**ITEM E1 - Clan Maxwell Estates Woodland Hollow Addition**

KPB File # 2022-017

<b>KPB File No.</b>	2022-017
<b>Plat Committee Meeting:</b>	March 21, 2022
<b>Applicant / Owner:</b>	Robert J Cutler of Anchorage, AK Maxwell Enterprises LLC of Seattle, WA
<b>Surveyor:</b>	Ken Lang / Lang & Associates, Inc
<b>General Location:</b>	Big Bear Circle, Bear Creek

**STAFF REPORT**

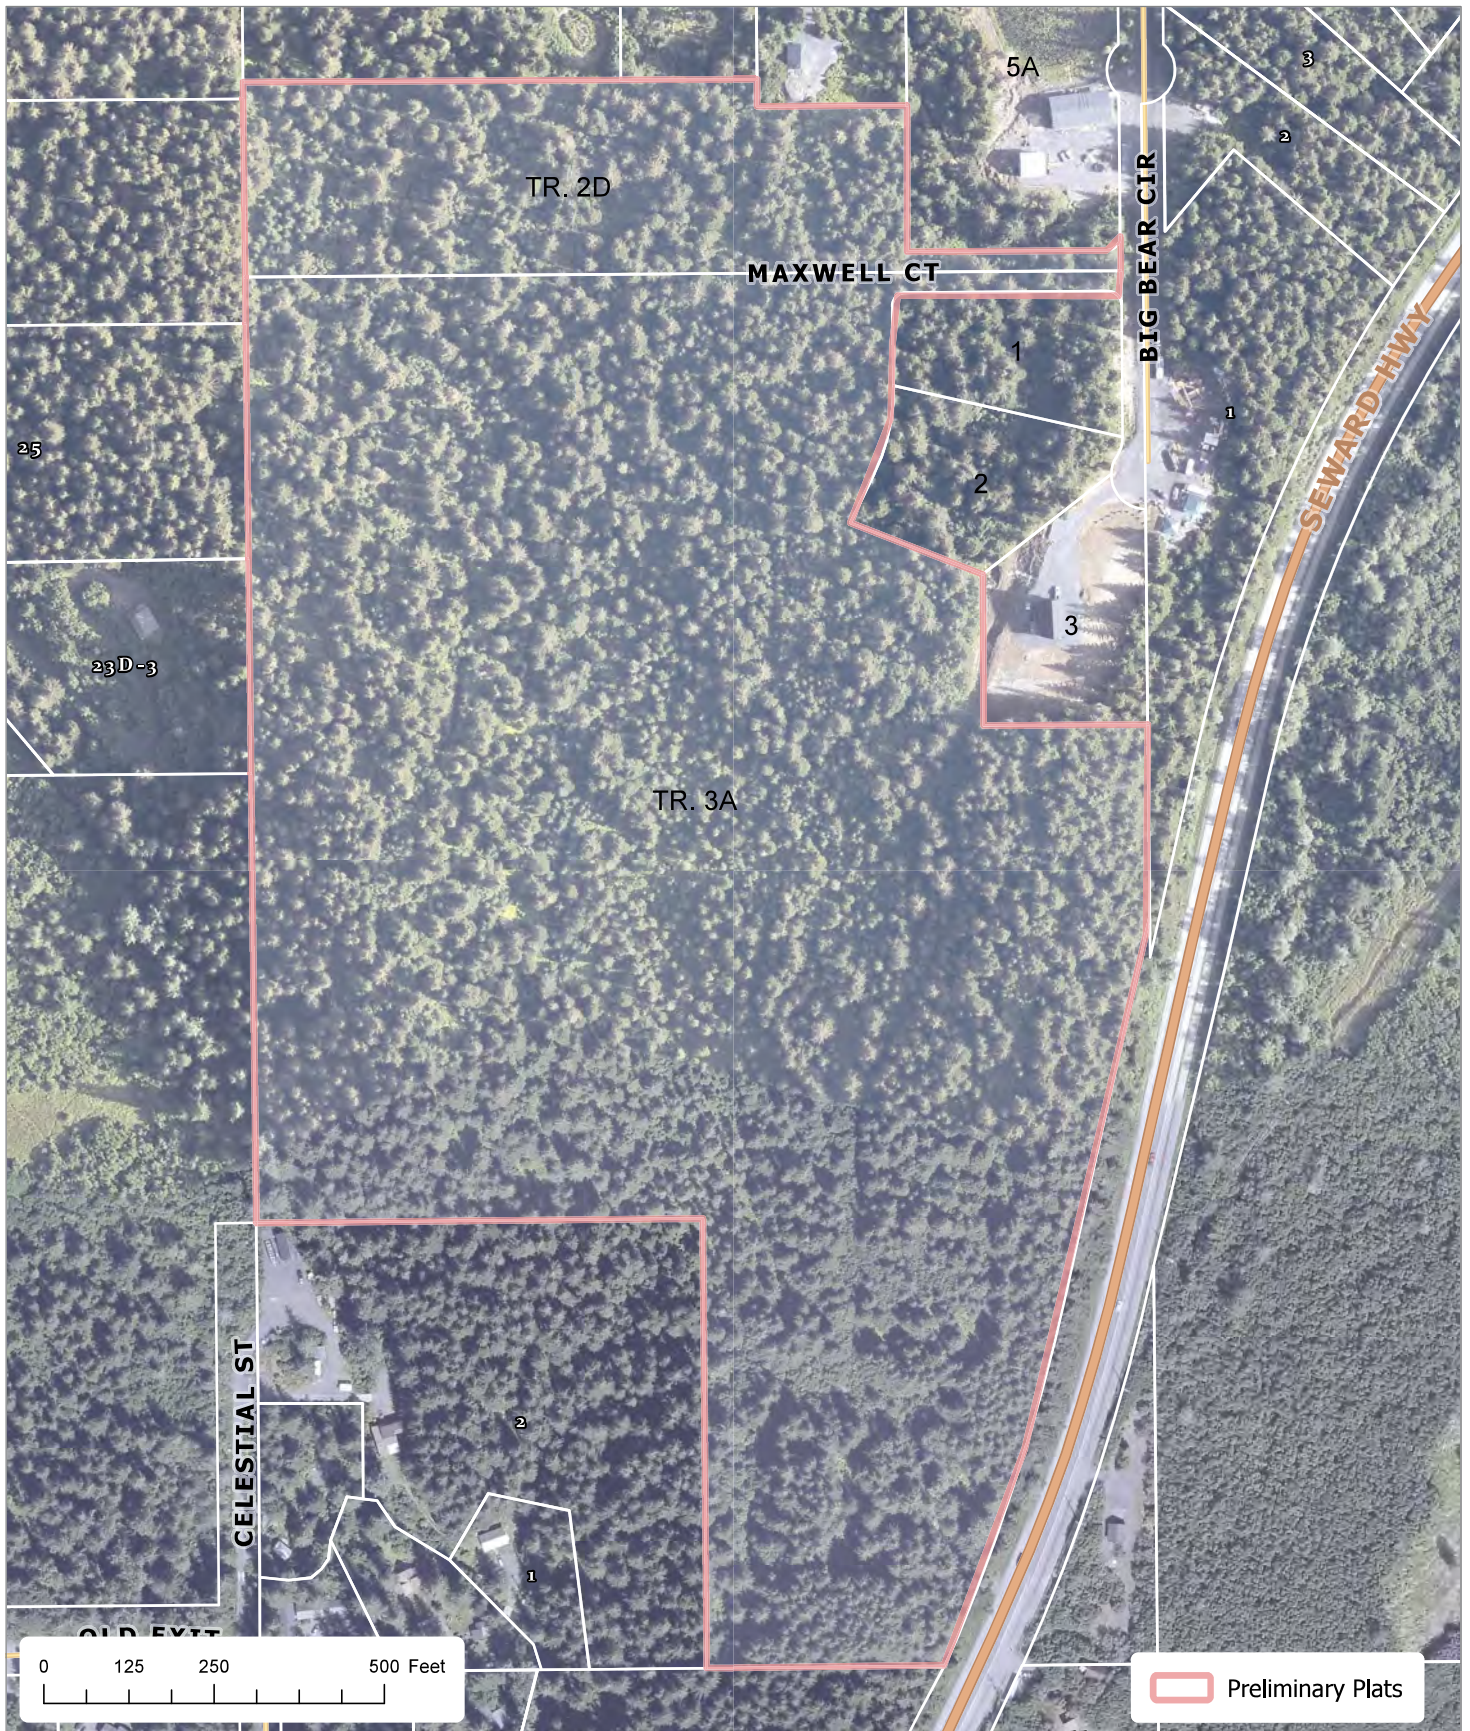
**Site Investigation:** The preliminary plat contains the contour information. There are various areas with steep slopes. **Staff recommends** the contours be removed from the final plat but the top or toe of any steep areas be depicted and labeled.

The preliminary plat indicates an area of inundation located in the southwest corner. KPB GIS data indicates an anadromous stream in that area. This stream is not a KPB managed steam and an anadromous note is not required. **Staff recommends** any low wet areas be depicted and labeled on the final plat and place a plat note, "Any person developing the property is responsible for obtaining all required local, state, and federal permits, including a U.S. Army Corps of Engineers wetland determination if applicable."

Per the KPB River Center review, the subdivision plat is within multiple flood zones and within the Seward Mapped Flood Data Area. **Staff recommends** a flood hazard note be required, depict and label mapped flood zones, and provide a plat note that references the Map Panel.

granting all easements shown for the intended uses, a public access easement was created. **Staff recommends the 33 foot access easement be shown and labeled noting "per Plat SW 86-06".**

A plat note will need to be added to grant 10 foot utility easements along the dedications and should be depicted if possible. **Staff recommends the code required 10 foot utility easements be granted, include depiction, and provide the correct plat notes.**

- Platting staff consulted the Addressing Officer and Exit Glacier Road should be revised to "Old Exit Glacier Road".

- *The proposed subdivision name is one of the parent subdivision's name. A new name must be submitted to be approved by Platting Staff. Staff suggests "Clan Maxwell Estates Woodland Hollow Addition 2".*
- *Owners should be added to the title block.*
- *Tract 2D needs the full subdivision name added, "Clan Maxwell Estates Avalon Heights Addition #4".*

- *Provide a width label for the Seward Highway or a "width varies" label.*
- *Provide a reference to the state project map either within the right of way depiction or within a plat note.*
- *The right of way dedicated with Plat No 2014-24 should be more obvious and may be once contours are removed.*
- *The section line easements not within right of way dedications should be depicted and labeled.*
- *Update the road name to "Old Exit Glacier Road" and provide a width label.*

- Provide a width label for Celestial Street.
- The dedication of Celestial Street continues north to the southwest corner of the preliminary plat.

- The depiction should be revised to exclude lots of Plat 2014-24 that are not part of this subdivision.
- There are multiple dark lines present with no labels. Please remove or provide labels.
- There are overstrikes on the section labels and some of the other labels. Make sure all labels are legible.

**Staff recommendation:** The new right of way will required an approved street name. The section line easement located along the southern border and eastern border should be labeled and depicted.

**Staff recommendation:** Update the subdivision labels to the west. Lot 25 is from Gentles Subdivision but Lot 23D-3 is from Gentles Subdivision Lyon Addition. A block label should be provided for the lots within Harbor View Subdivision.

**Staff recommendation:** Tract 3A will require a new designation. Staff recommends Tract 3B.

**Staff recommendation:** *The boundary must be revised to exclude the lots and right of way dedications that are not included within this subdivision.*

**Staff recommendation:** Verify which state Mr. Maxwell will be signing in and update the Notary accordingly or leave blank. Next to each owner's name, include the parent tract number they are signing on behalf. Include a right of way acceptance to be signed by the borough. Comply with 20.60.190.
